Sub- Modification of control circuit of ac dual break locomotive provided with static converter with soft start for rolling stock application.

Modification Sheet No. ELRS/ MS / 0318. (REV— 0)

Modification of control circuit of dual break ac locomotives provided with Static converter for Soft start of Auxiliaries except compressor and Exhauster.

| TRACTION CONTROL CIRCUIT WITH 180 KVA STATIC CONVERTER WITH SOFT START. | | FIRST ISSUED |

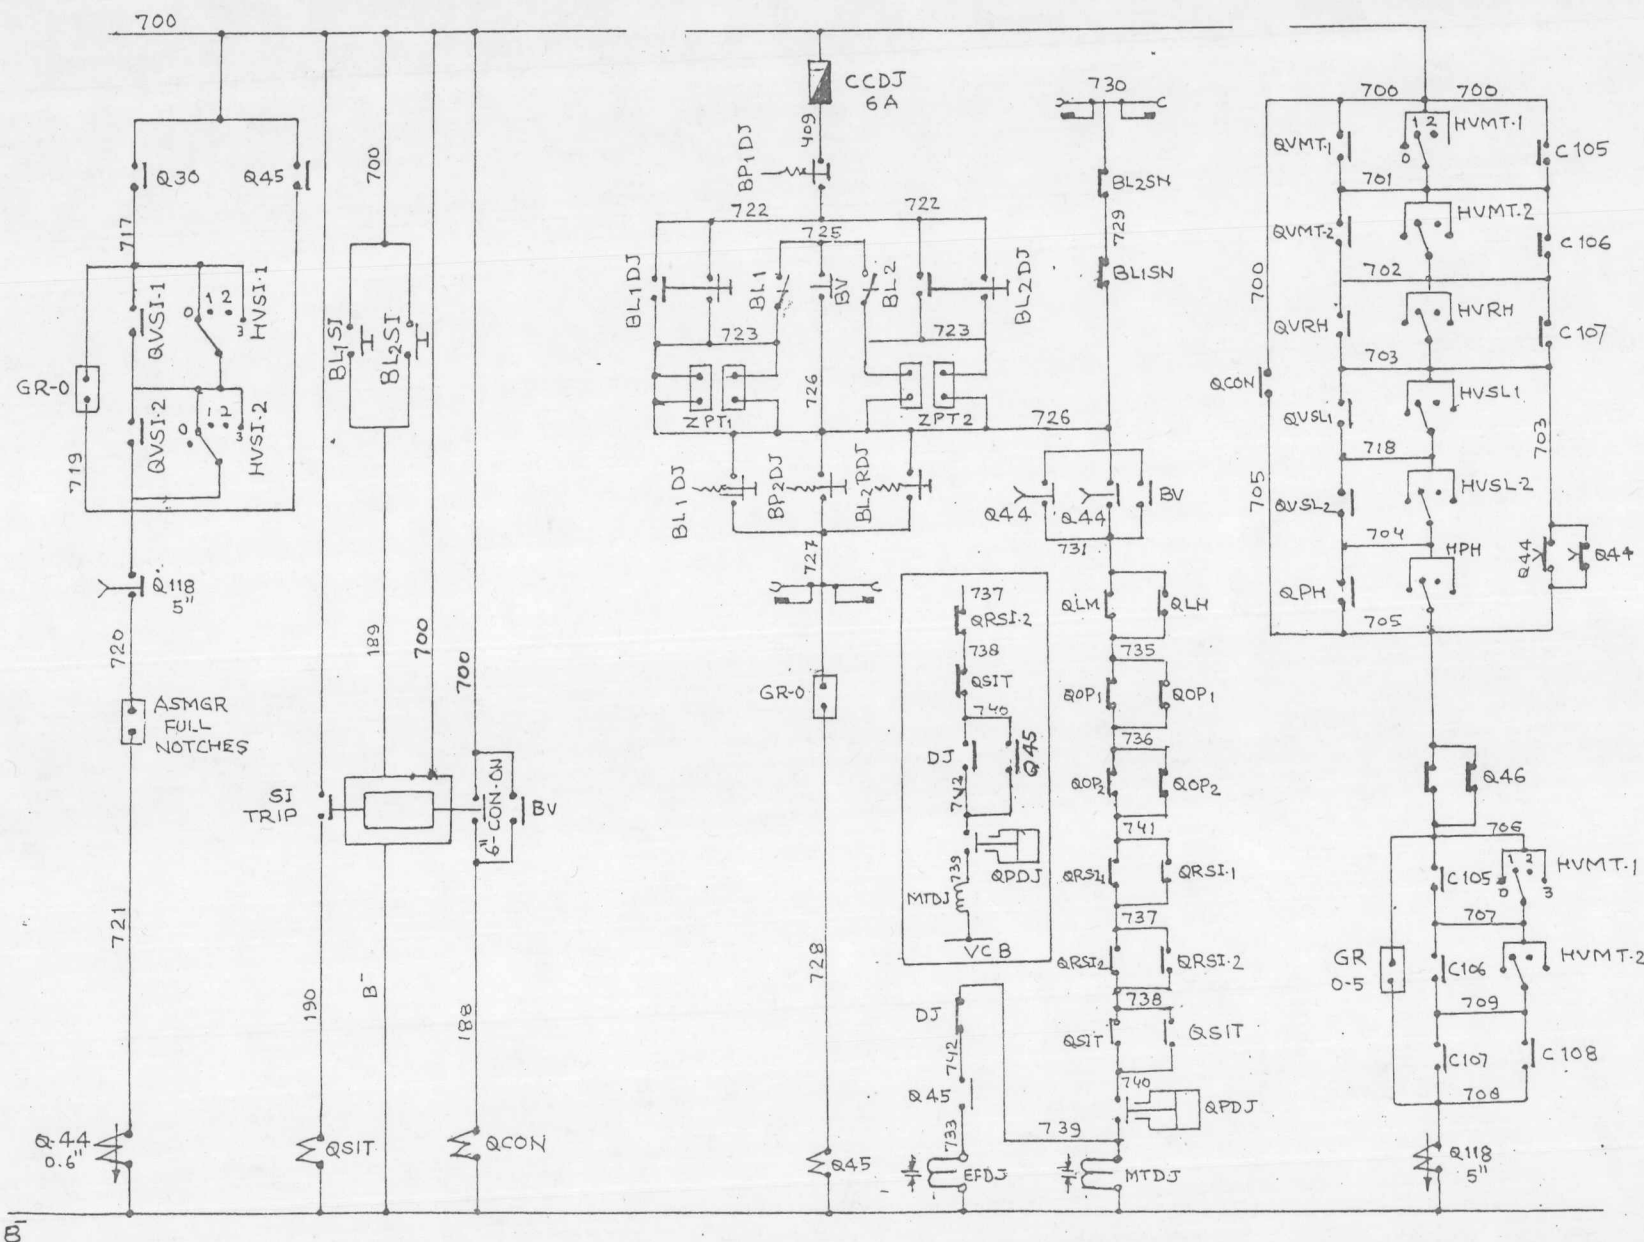
| | 1 | QCON N/C Contact removed from VCB CRT. | <i>[Signature]</i> | 24.4.02 |
